Results of Independent Testing of SFEI's Multibox Model for PCB Fate and Transport

Prepared For:
Clean Estuary Partnership

Prepared by:
 Tetra Tech, Inc.
Lafayette, CA

September 2, 2005

Figure 7. Total PCB concentrations versus depth in sediments in San Pablo Bay.

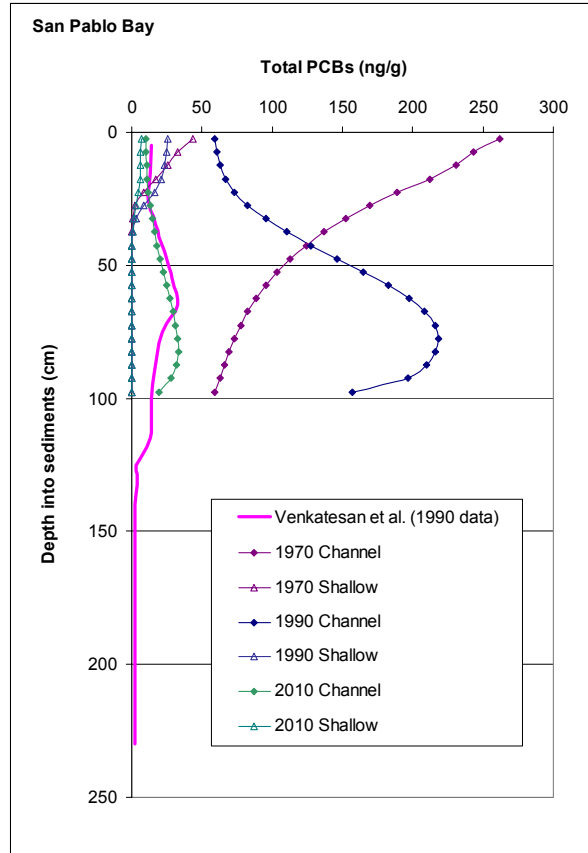
9. A number of other miscellaneous suggestions are provided throughout the report. They are:
 - Discuss why the two modeled PCB profiles for 1970 and 1990 differ as much as they do (see Figure 7).

While this equation was not rigorously verified, units were checked and found to be consistent throughout. As an additional check, several time-variable depth profiles of PCBs in the sediments were plotted and visually evaluated. An example for San Pablo Bay is shown in Figure 7. Focusing on the 1970 and 1990 channel profiles, it appears that those two sediment profiles differ significantly over depth, considering that they represent predictions that are only 20 years apart. An explanation of whether these differences are plausible should be provided.

2) (pages 26-27) - I can make a more detailed presentation of the sediment mixing equations in the next report. Regarding whether or not I think the change in profiles over 20yrs is reasonable... A purely diffusional timescale to move 50cm into the sediment profile is on the order of 30-35 years (given $D_b \sim 70 \text{cm}^2/\text{yr}$). Add deposition (which it appears like this core represents) and the mass could move more quickly.

Figure 8. Time series of hindcast and forecast precipitation used by MBM.

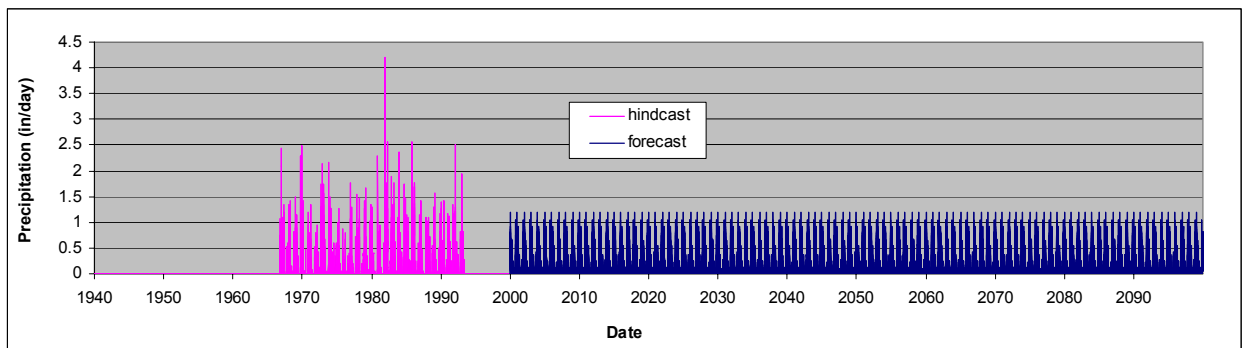
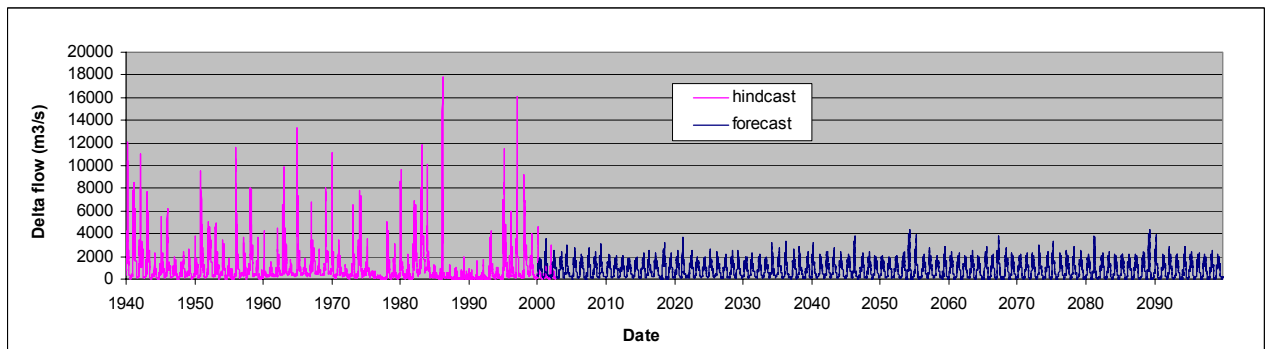
Figures 8 and 9 show the time series of hindcast (in pink) and forecast (in blue) of precipitation and Delta flow rates used by MBM. These two graphs illustrate the two points mentioned above. Knowles and Cayan (2002) provide one option to add variability back to forecast precipitation and Delta flow rates. It is suggested that this method be reviewed and evaluated for suitability to the present work.

The MBM model developers chose to use climatological averages for future precipitation because of the uncertainty in how precipitation will change in California over the 21st century. Depending on which General Circulation Model (GCM) is used to make predictions and which greenhouse gas emissions scenario is simulated, GCMs predict quite different 21st century precipitation patterns and amounts in California. Some predictions show increasing precipitation, while others show decreasing amounts of precipitation (Hayhoe et al. 2004). Thus, assuming that the total annual rainfall will remain at historical levels is a reasonable assumption. Knowles and Cayan (2002) use this assumption in their analysis of projected 21st century Delta flow rates.

Figure 10. Time series of hindcast and forecast suspended solids concentrations at Freeport used by MBM.

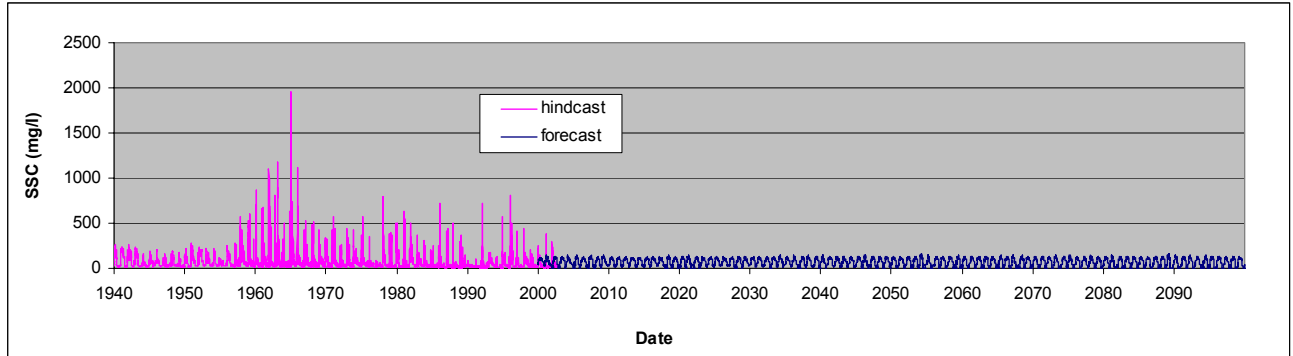
The hindcast and forecast suspended solids data at Freeport are shown in Figure 10. The suspended solids concentrations have close to the same mean values, as expected, but the variability in the forecast data series is lower (see Table 3).

Figure 11. Time series of hindcast and forecast evaporation rates used by MBM.

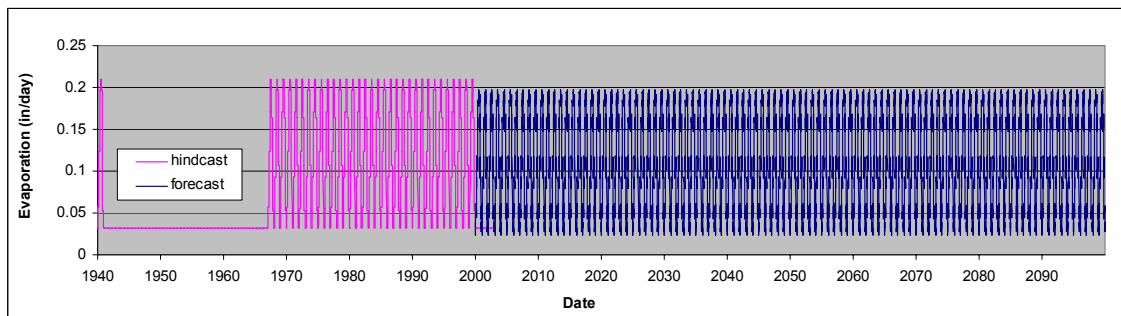
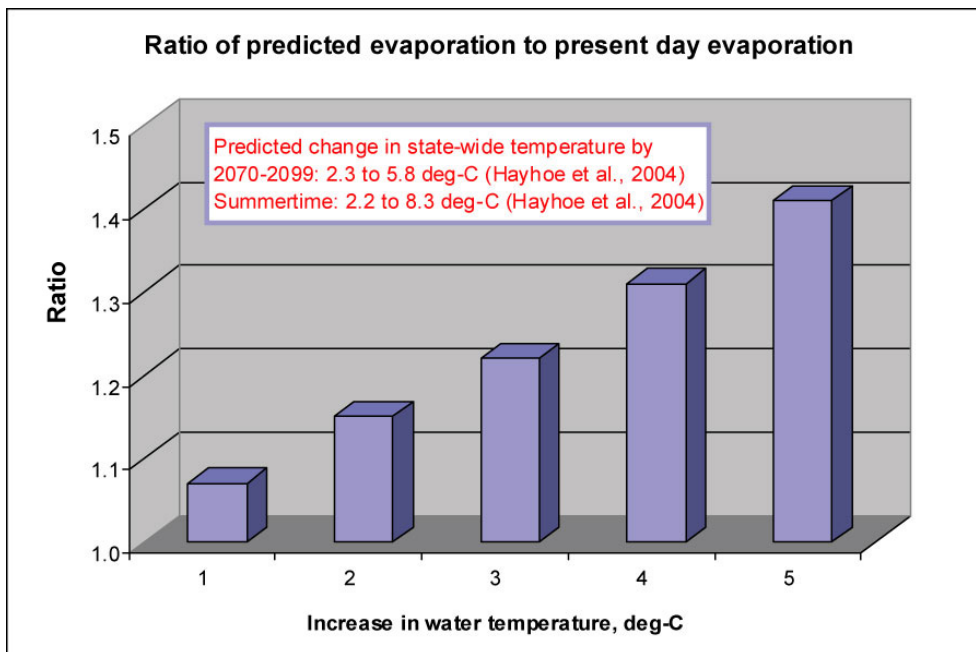
Figure 11 shows the time series of hindcast and forecast evaporation rates from the Bay. Two anomalous conditions are illustrated: the 30-year period of missing data early in the hindcast, and the small but apparent shift in evaporation rate at the interface of the hindcast and forecast periods. Both of these issues should be addressed. Additionally, recent studies have shown that the state will warm over the 21st century due to increasing greenhouse gas concentrations (Knowles and Cayan 2002; Hayhoe et al. 2004). Ultimately the increased surface temperatures could lead to increased water temperatures, which could affect evaporation of Bay water, which in turn could influence circulation in parts of the Bay where residence times are large, such as Lower South San Francisco Bay. Figure 12 illustrates the possible influence of increased water temperatures on evaporation. For water temperature increases in the range of 1 °C to 5 °C, evaporation losses can increase by 5 percent to 40 percent.

Andy sent you my CEP Powerpoint, which can serve as my response to the SSC problems. We have added the missing evaporation data. Thank you for your helpful comments, Dave

Figure 13. Time series of hindcast and forecast tidal states used in MBM.

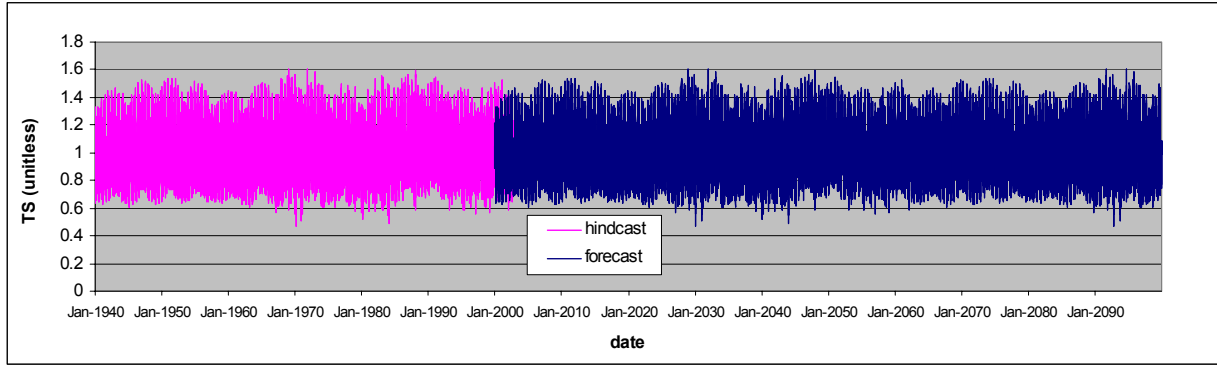
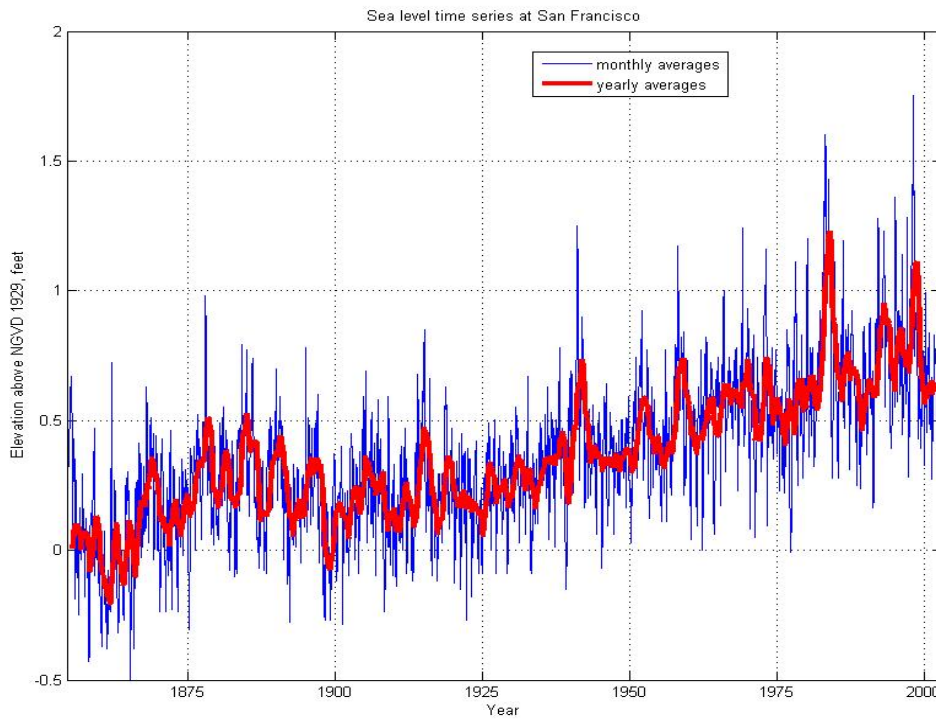
The tidal state (TS) time series for the hindcast and forecast periods is shown in Figure 13. TS is used as input to the UP model (Uncles and Peterson 1995, 1996) that calculates salinity distribution throughout the estuary. TS is a dimensionless parameter whose magnitude varies by tidal amplitude. At the Golden Gate, de-trended water level data are used to calculate TS (Uncles and Peterson 1996) and it does not appear that the effects of future sea levels are considered. The historical sea level data at the Golden Gate clearly shows an upward trend over the past 100 years (Figure 14). Model predictions groups indicate that sea level rise over the 21st century could accelerate (Hayhoe et al. 2004). For example, the relative sea level rise at the Golden Gate during the 20th century was approximately 13 cm. Towards the end of the 21st century, the sea level could increase another 19 to 41 cm (Hayhoe et al. 2004). The work of Knowles and Cayan (2002), which applies the UP model to San Francisco Bay to evaluate the effects of global warming on the Bay, indicates that higher salinity levels will exist in the Bay. It is suggested that the UP Model be tested over different periods within the forecast period to examine the effect of increasing sea level.

Figure 15. Time series of hindcast and forecast wind speed at SFO used in MBM.

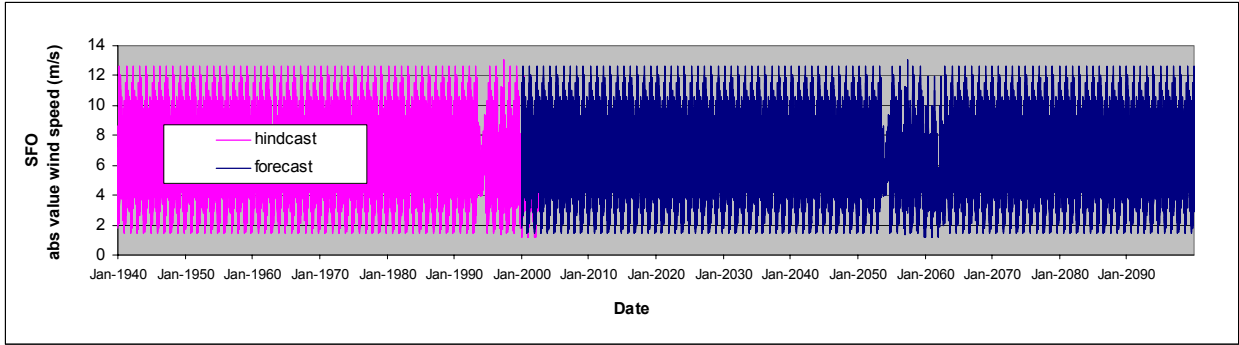
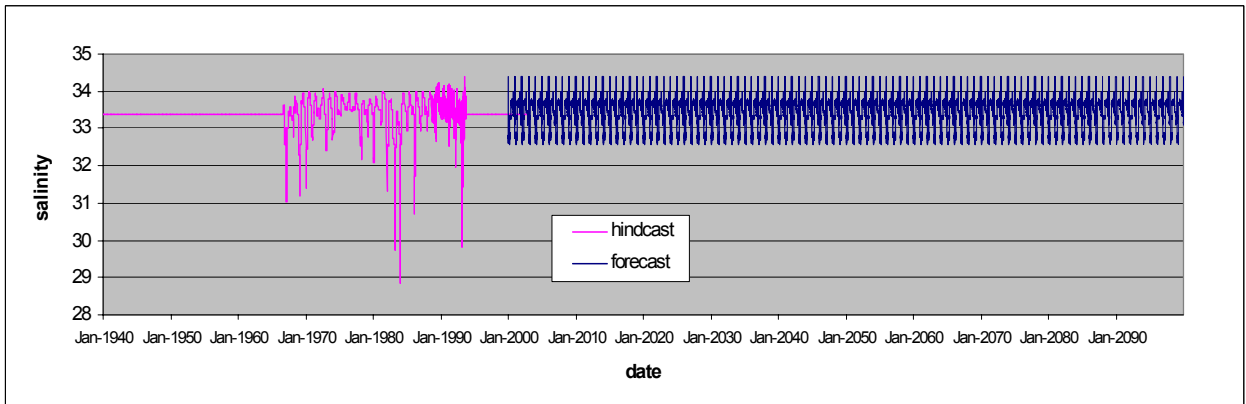
The last two input data sets examined consist of wind speed at San Francisco Airport (Figure 15) and salinity used for the ocean boundary condition (Figure 16). No specific suggestions are provided herein for changing wind speed. The boundary salinity data could be modified to add variability to the constant portions of the time series.

Figure 17. Time series of predicted suspended solids concentrations in boxes 3 and 37 illustrating the “Spin-up” Period.

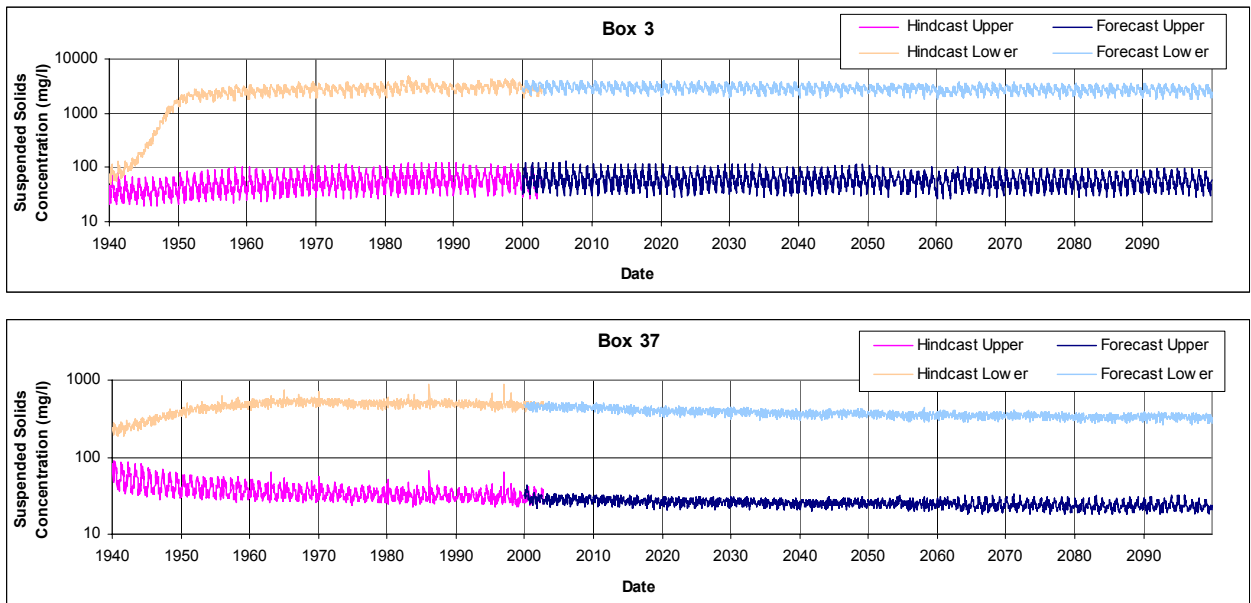
The hindcast period began in 1940, for which model initial conditions were developed. The initial conditions include PCBs in bedded sediments, which were set to zero. As the model simulations proceed onward from 1940, it appears that the Bay's suspended solids undergo an adjustment period of a decade or so, as shown, for example in Figure 17. This is typically called a spin-up period, and is often unavoidable because actual initial conditions are not known. It is possible to remove the influence of the spin up period by either initializing the model earlier in time and ignoring the spin-up period in terms of reporting results, or delaying PCB loads into the Bay until after the spin-up period. For this modeling application, PCB loads were added during the spin-up period and could result in unrealistic PCB transport during that time period.

Also, in 1940 PCBs had already been discharged to the Bay (from as early as 1927) according to the Breivik curve analysis reported in the draft report. By about 1940, the loading of PCBs exceeded today's loading rates by about 20 times (as shown later in Figure 30), so the assumption that the sediments were free of PCBs in 1940 is not consistent with the Breivik curve approach.

Alternative choices exist for how the model is initialized. One choice, for example, would be to initialize the model to the year PCB discharges to the Bay were thought to have begun (1927). For that starting time it would be appropriate to initialize the sediments as

4) Model Initialization (pages 42-44) - I agree there are issues with initialization in both the hindcast and the forecast. The hindcast represents a very different problem, as it involves model spin-up. We can change the start date for the hindcast model. However, it is currently calibrated so that net sedimentation during 1951-1983 matches observations (if I remember correctly). It may be best to start PCBs much later, maybe in the 90s, according to existing field data and then see how they get redistributed. I don't see the forecast as having the same spin-up issues. The spin-up problems seem to be minimized when the model is initialized with box volumes equal to those at the end of the hindcast.

Figure 18. Comparison of predicted and observed suspended solids concentrations in box 3 (model predictions are 14-day averages). UPS V.1 results are shown for reference (from Leatherbarrow et al, 2005).

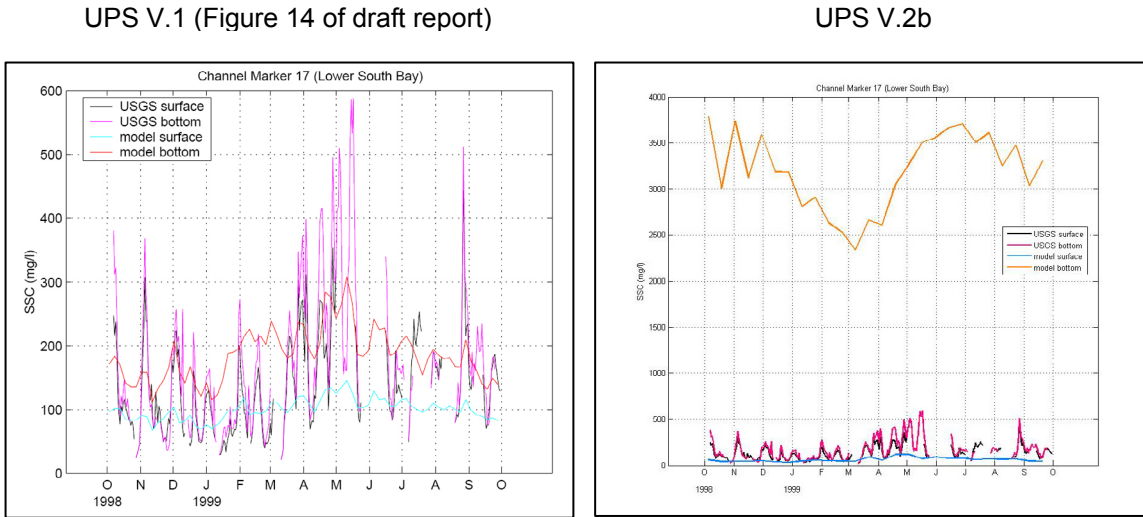
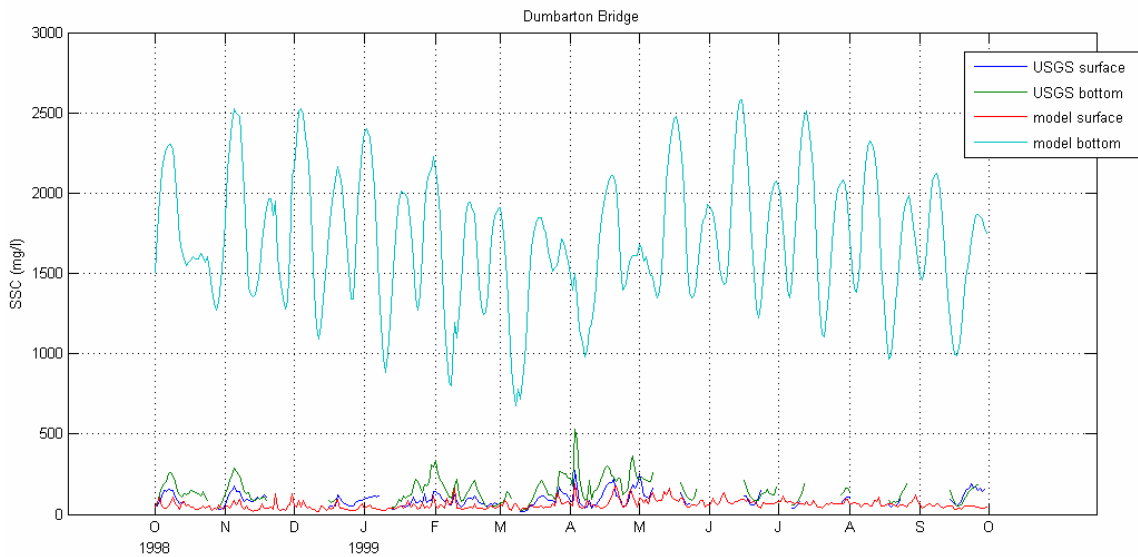
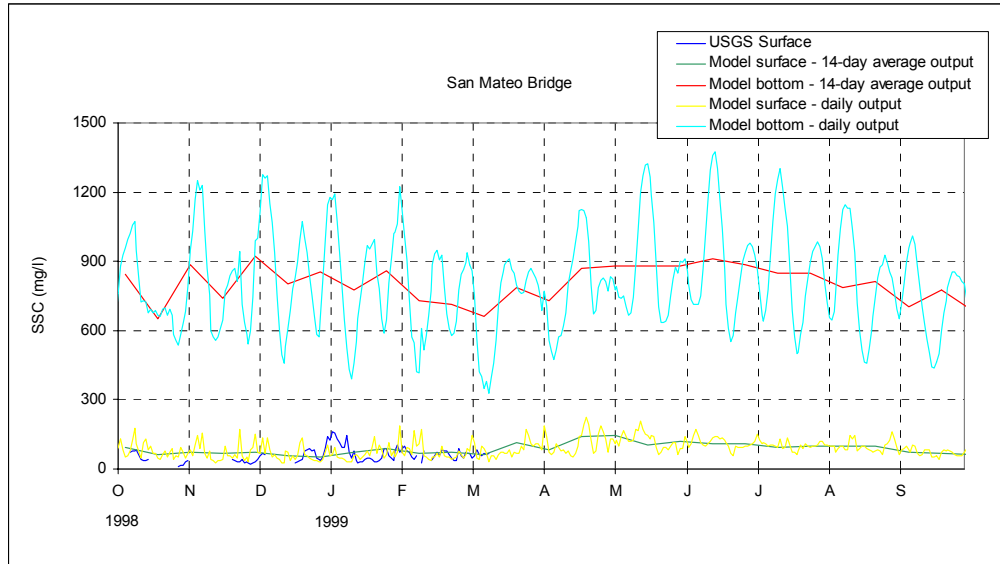
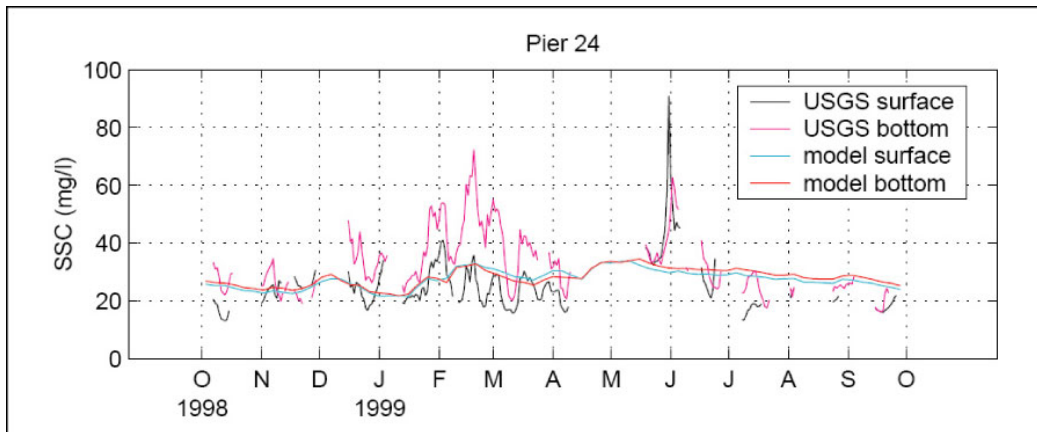
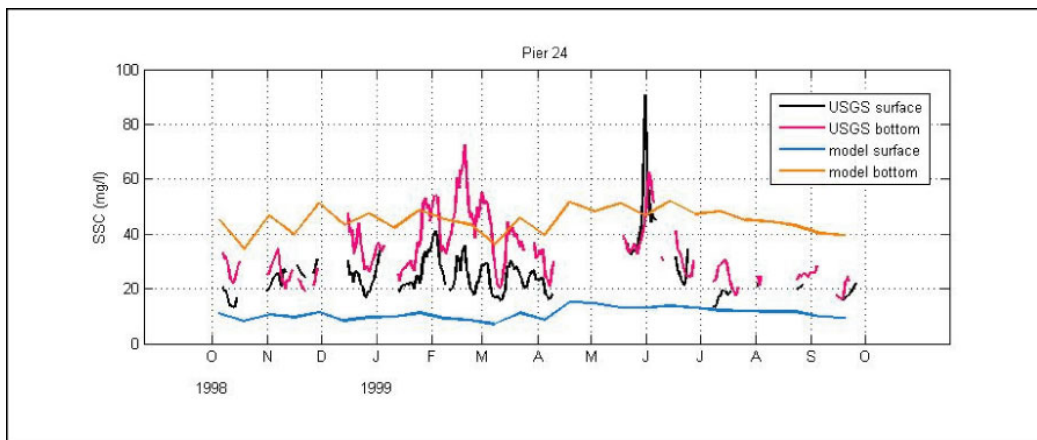
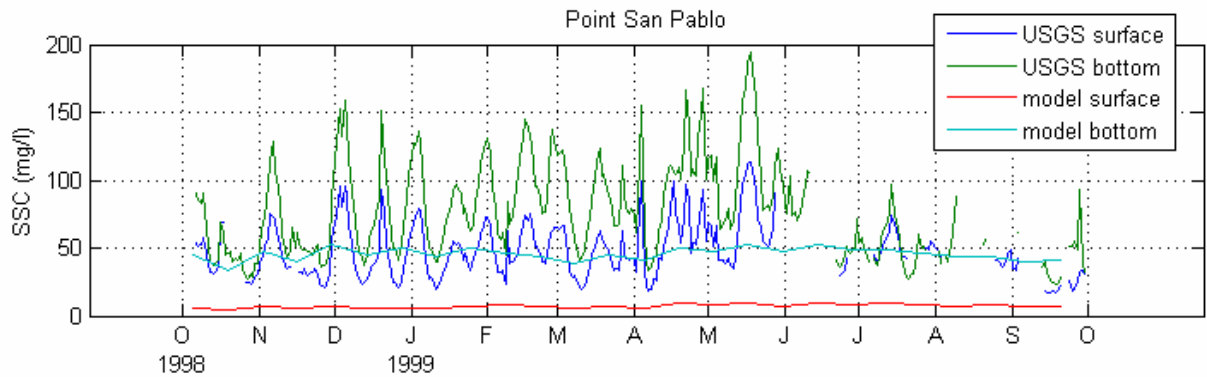
A comparison of predicted and observed suspended solids concentrations at locations around the Bay for a 12-month period beginning in October 1998 is shown in Figures 18 through 22. The predicted concentrations are either 14-day averages (averaged over a spring-neap cycle) for each of the two layers within each box, or daily model output. As

expected, the 14-day averages show less variability. At locations in the South Bay (Figures 18, 19, 20) the most noticeable features of the plots are the consistently higher model-predicted concentrations compared with USGS data. While some differences are expected, since the model predictions are volume averages, this behavior of higher predicted concentrations is consistent. This behavior is not observed, however, at Pier 24 (Figure 21) and Point San Pablo (Figure 22).
